REMARKS

AMENDMENTS TO THE DRAWINGS

Fig. 2
Prior Art

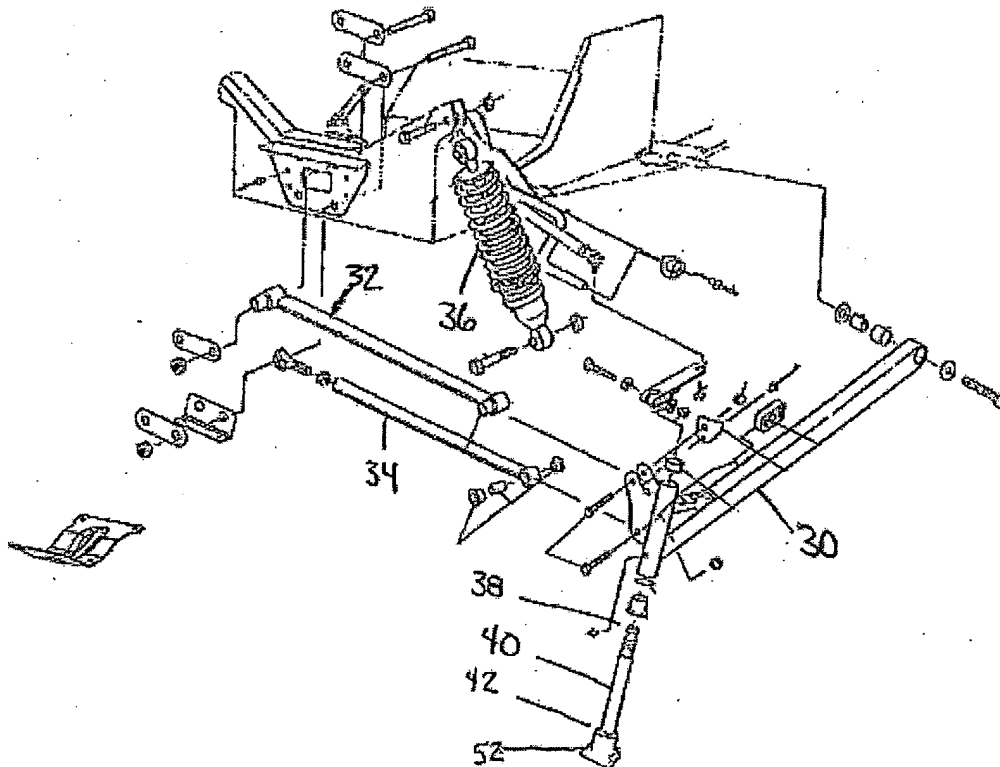
Figure 2 was objected to for having reference numbers that did not appear in the disclosure. Figure 2 has been amended to remove the reference numbers not identified in the disclosure and to remove the short lead line pointing towards a rectangular shaped object on the far left hand side of Figure 2.

Enclosed are replacement Figures 2 and 4, which will replace all prior versions of the figures in the application.

FIGURE 4

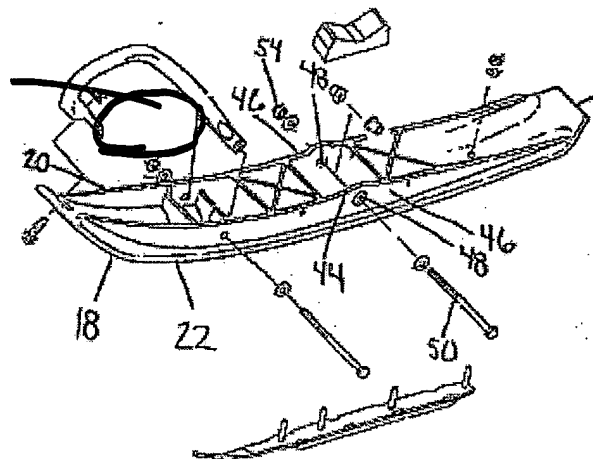
Figure 4 has been amended to more clearly show the central point 77 between the first end 70 and second end 72 of the bushing 66. No new matter has been added to the application, as this information was already contained implicitly and explicitly within the specification and figures.

The specification has been amended to add reference number 77 for a central point between the first end 70 and the second end 72 of the bushing 66 within the final paragraph on page seven. Reference number 77 was also amended in Figure 4 to clearly call out the central point claim element. No new matter has been added to the application, as this information was already contained implicitly and explicitly within the specification.
